Amphenol Taiwan Corporation Product Change Notification

Part Numbers Concerned :	G97R24*; G42RA4*; G42R14* Series	Originator:	Sondra Sang
Product Description:	MINI COOL EDGE IO INTEGRATED RA CONNECTR 124PIN	Issue Date:	2022/07/11
		PCN NO:	NE22116
Distribution:	Process optimization.	Old Rev.	G97R_AX16 G42RA_B G42R1_B
		New Rev.	G97R_AX16 G42RA_B G42R1_B

Product Change Notice

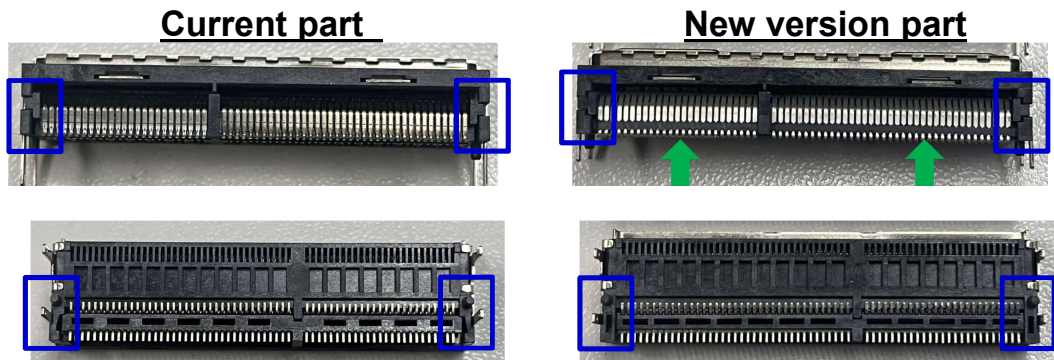
1. Add hot melting process on rear tails to control the Coplanarity easier. (green arrow)
2. Slightly modification to optimize the assembly process to make it more fluency. (blue circle)
